FPL

L-2008-121
10 CFR 50.90

RE: St. Lucie Units 1 and 2
Docket Nos. 50-335 and 50-389
Proposed License Amendment
Request for Additional Information Response
Alternative Source Term Amendment – TAC Nos. MD6173 and MD6202

TS Mark Ups

Page 3/4 3-21
Page 3/4 3-22

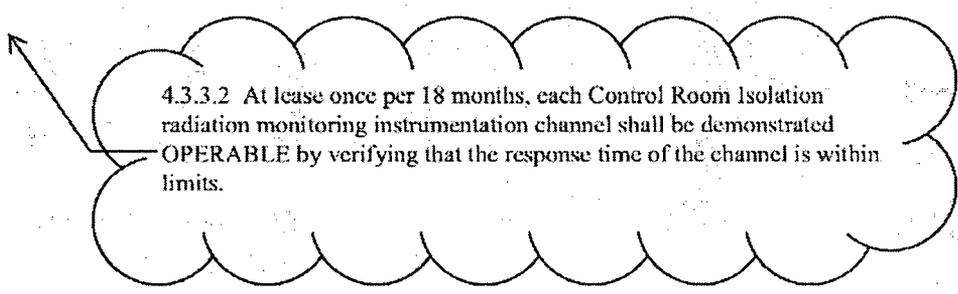
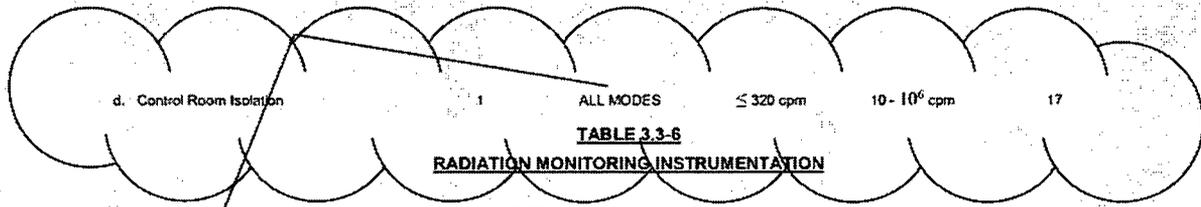
4.3.3.2 At least once per 18 months, each Control Room Isolation radiation monitoring instrumentation channel shall be demonstrated OPERABLE by verifying that the response time of the channel is within limits.

TABLE 3.3-6
RADIATION MONITORING INSTRUMENTATION

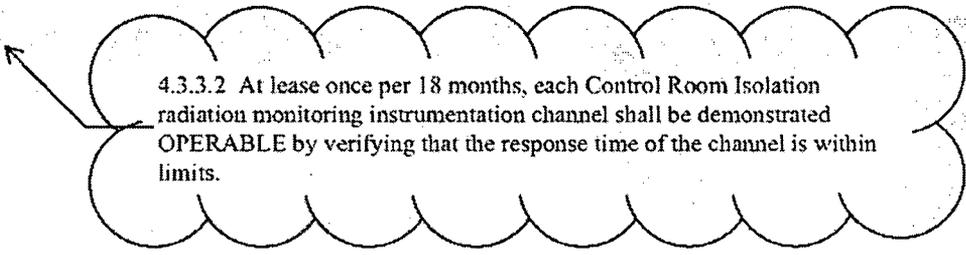
4.3.3.2 At lease once per 18 months, each Control Room Isolation radiation monitoring instrumentation channel shall be demonstrated OPERABLE by verifying that the response time of the channel is within limits.

≤ 320 cpm
